## SYDNEY NORTH PLANNING PANEL

<b>Panel Reference</b>	PPSSNH-204
<b>DA Number</b>	LDA2021/0095
<b>LGA</b>	City of Ryde
<b>Proposed Development</b>	Alterations and additions to the existing garden centre and construction of an 18-storey office building at the site including a multi-level car park and additional dining space.
<b>Street Address</b>	307 Lane Cove Rd Macquarie Park
<b>Applicant/Owner</b>	Thunderbirds Are Go Pty Ltd Atf The Gardeners Trust/ Thunderbirds Are Go Pty Limited
<b>Date of DA lodgement</b>	30 March 2021
<b>Number of Submissions</b>	246
<b>Recommendation</b>	<b>Refusal</b>
<b>Regional Development Criteria - SEPP (Planning Systems) 2021</b>	General Development over \$30 Million –  Capital Investment Value: \$155,581,524.80
<b>List of all relevant s4.15(1)(a) matters</b>	<ul style="list-style-type: none"> <li>• Environmental Planning and Assessment Act 1979;</li> <li>• Environmental Planning and Assessment Regulation 2000;</li> <li>• State Environmental Planning Policy Resilience and Hazards 2021 <ul style="list-style-type: none"> <li>- Chapter 4 Remediation of Land</li> </ul> </li> <li>• State Environmental Planning Policy – Biodiversity and Conservation 2021 <u

**Figure 20** Recommended height of buildings shown in purple. 37m recommended along the south-western portion of the site and 26m to the north west

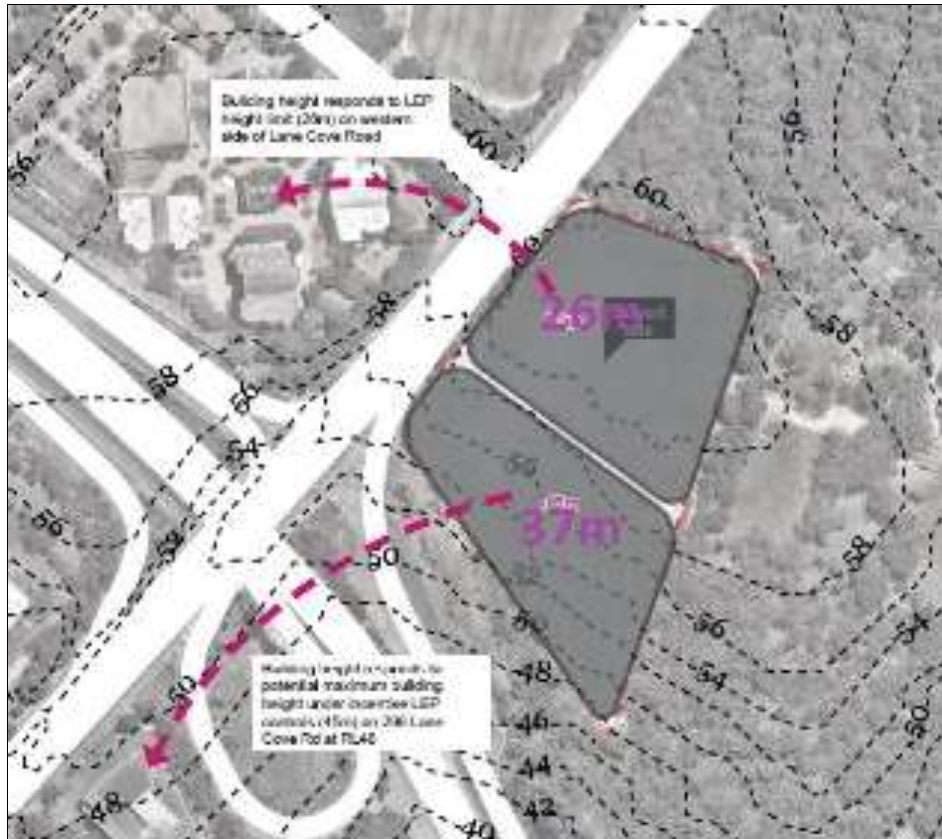
20 September 2021	Council staff met with the Applicant to discuss concerns with the proposal. Council outlined the preferred height options for the site. Council advised preference for two (2) buildings with heights of 37 metres and 26 metres ( <b>Figure 20</b> ). The heights were based on the topography of the site, and surrounding permissible heights afforded under RLEP 2014.

**Figure 23** Site plan showing fire booster circled in red and main pedestrian access in green outlines by CPS  
Source: DKO Architects

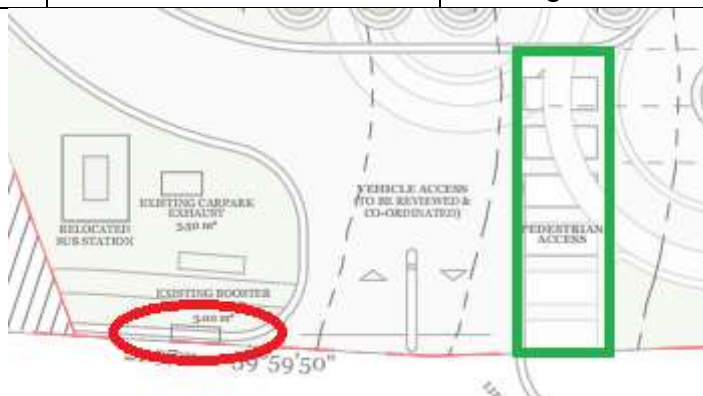
D1.9	The total distance from the basement carpark to road or open space via non fire isolated stair is greater than 80m (approximately 90m)	
E1.3, E1.5	The hydrant and sprinkler booster will not be located adjacent to the main vehicle entry and within sight of the principal pedestrian entry	<p>The existing booster cupboard is located to the north of the main driveway access into the site and is not considered to be within sight of the principal pedestrian entrance (<b>Figure 23</b>).</p> <p>The site is landscaped in front of the existing booster.</p>

**Figure 24** Proposed fire services room outlined in red by CPS  
Source: DKO architects

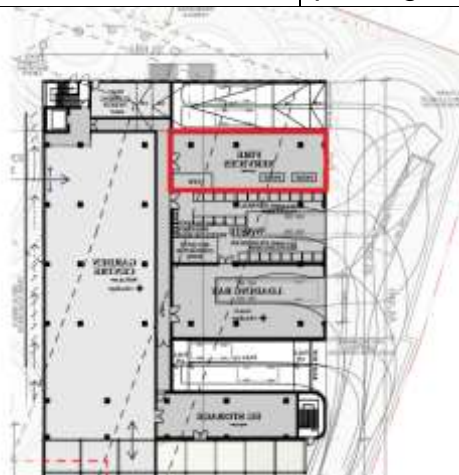
E1.8	The fire control room will not be accessible from the front entrance of the building	The proposed fire services room is located adjacent to the Lane Cove National Park and to the north east of the site beneath the proposed car parking structure ( <b>Figure 24</b> ).
------	--	---

These issues should be addressed in the current DA as some of the BCA solutions may result in changes to the built form.

**Figure 25** Extract of stormwater management plan Sheet 2 of 2 prepared by BG&E showing southernmost corner of the site where the stormwater design conflicts with the proposed landscape design.

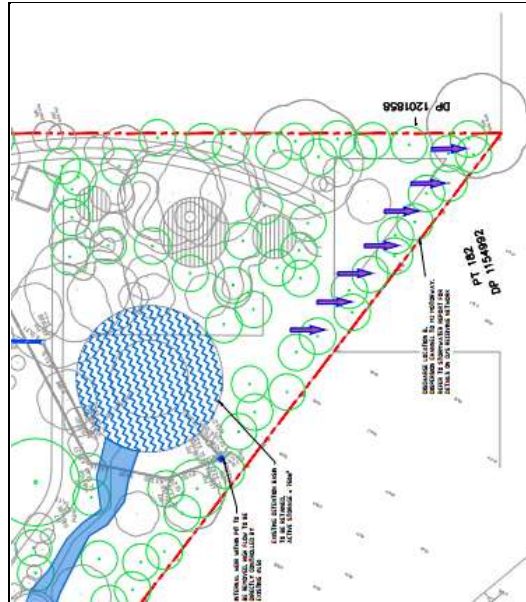
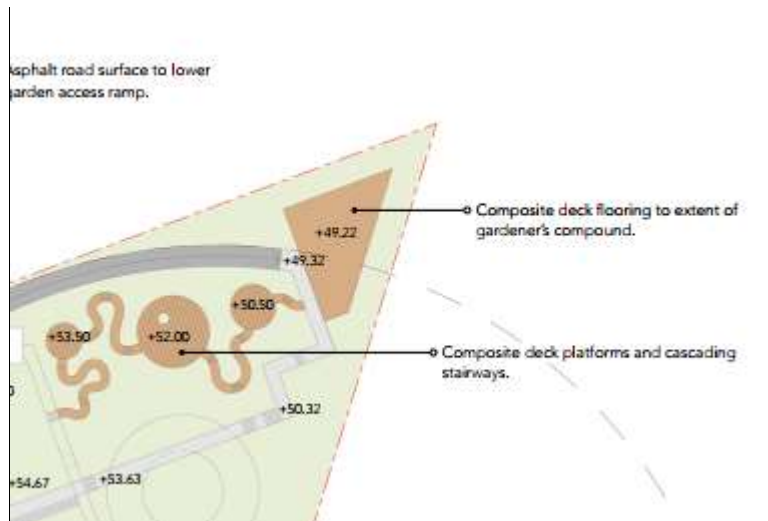
The proposal relies upon a dispersal system and the stormwater management report prepared by BG&E which indicates runoff will be directed to a 35m long dispersal channel at the southernmost corner of the site. However, the submitted plans (**Figure 25**) do not detail this and there is potential conflict with the landscape plan which references composite decking and paths in this location (**Figure 26**). The proposal has been considered unacceptable by Council's Senior Development Engineer.

**Figure 26** Extract of landscape plan - hardscape/levels plan prepared by REALM studios showing southernmost corner of the site where the proposal conflicts with the stormwater design.

**Figure 27** Roof plan showing energy efficiency measures  
Source: DKO Architects

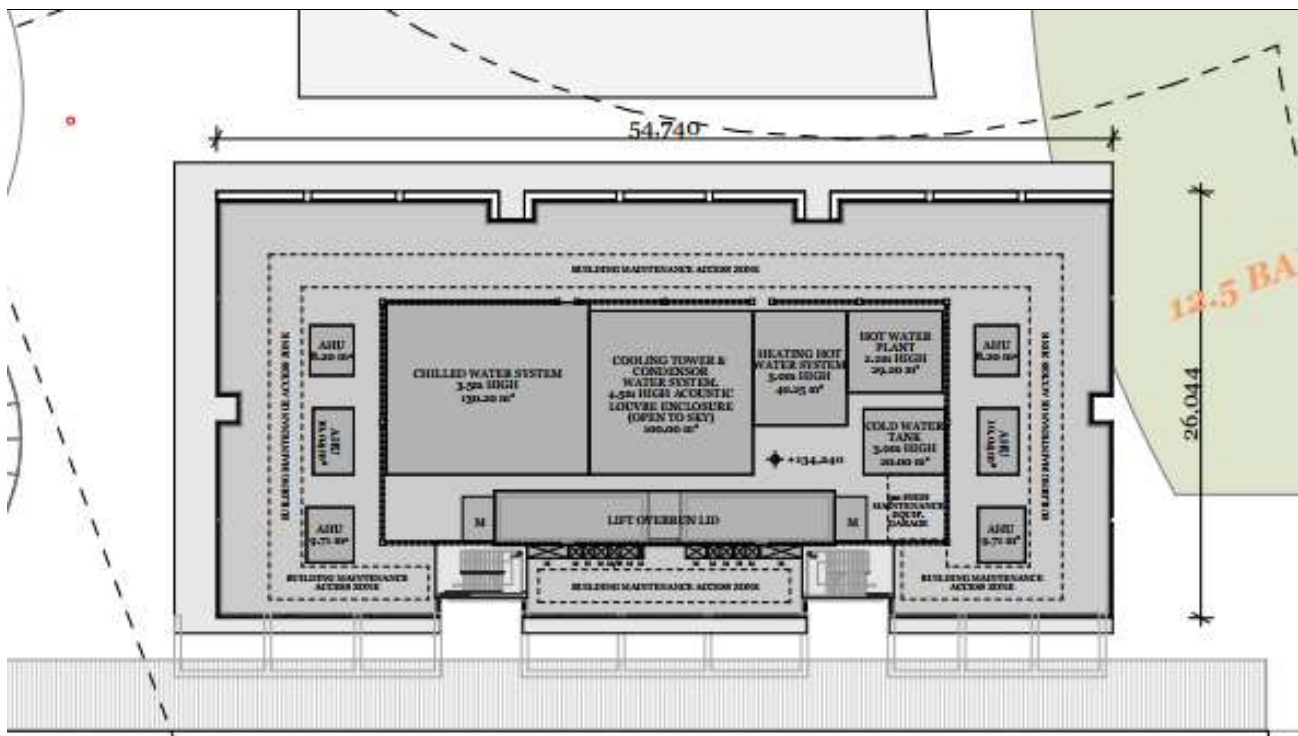
The submitted roof plan (**Figure 27**) references the development including a water system, heating hot water system, cooling tower, photovoltaic cells. The external elevations show external shading devices over both the car park and the ground floor of the office tower, in addition to winter gardens within the office tower. The garden centre contains external canopy areas, and solar panels are provided on the roof of the carparking building. For these reasons it is considered sufficient information has been included on the plans to satisfy the Environmental Sustainability provisions under clause 6.6 of RLEP 2014.

**Figure 29** Location of grease arrestor at lower ground floor outlined in red by CPS  
Source: DKO Architects

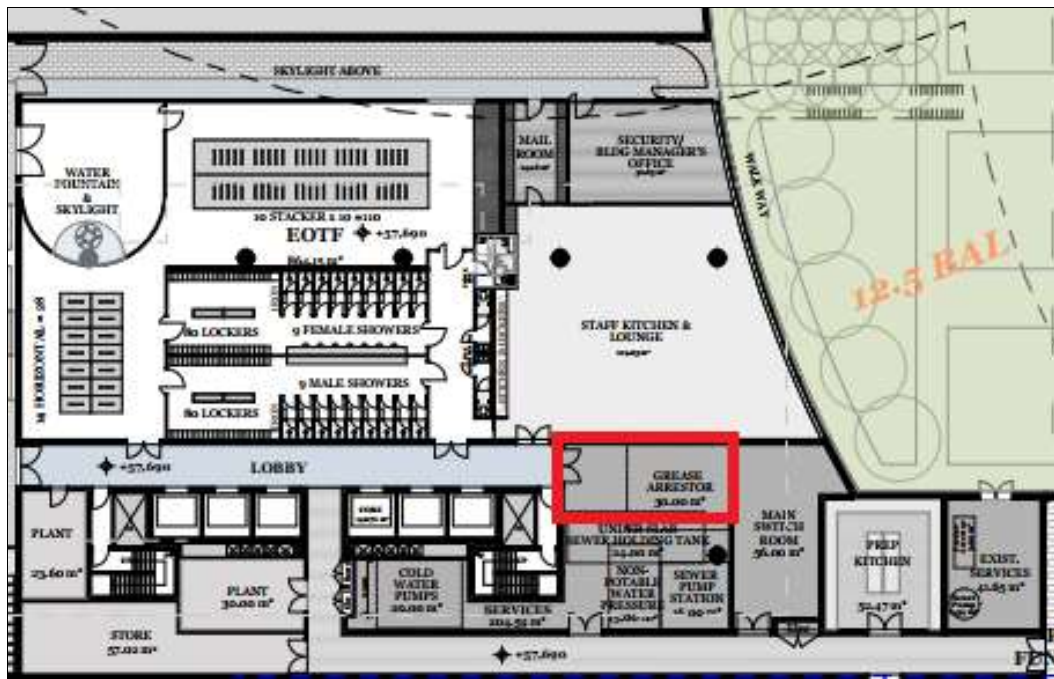
The grease arrestor associated with the restaurant is located at the lower ground floor within a separate service room (**Figure 29**). The room is accessible from the lobby and directly from the car ark to enable accessibility for contractors.
